Technical Journal

Rear tow hook cover, comes loose

REF NO: TJ 33542.1.0	ISSUING DEPARTMENT: Technical Service	CAR MARKET: United States and Canada	
PARTNER: 3 US 7510 Volvo Car USA		ISSUE DATE: 2019-01-15	STATUS DATE: 2019-01-21
FUNC GROUP: 8619	FUNC DESC: Miscellaneous	Page 1 of 3

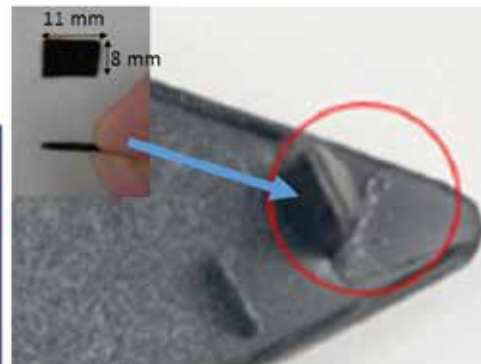
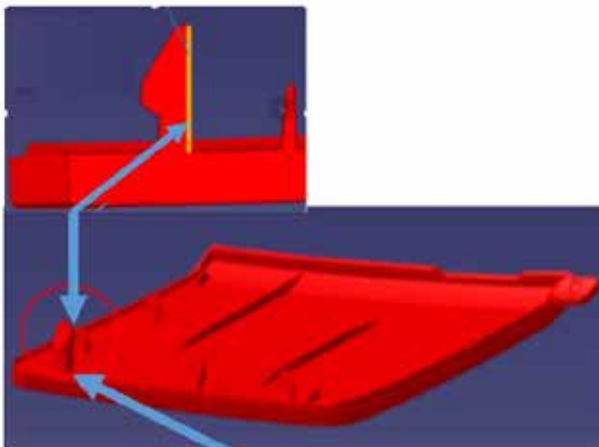
If the rear tow hook cover comes loose, follow the advice under service.

Use tape P/N 30643492 (50x25x0.6) and cut a small piece 8x11 mm.

Apply the tape on the locking tab in order to increase the thickness of the tab on the loose cover or the new cover, see attachment TJ33542.jpg.
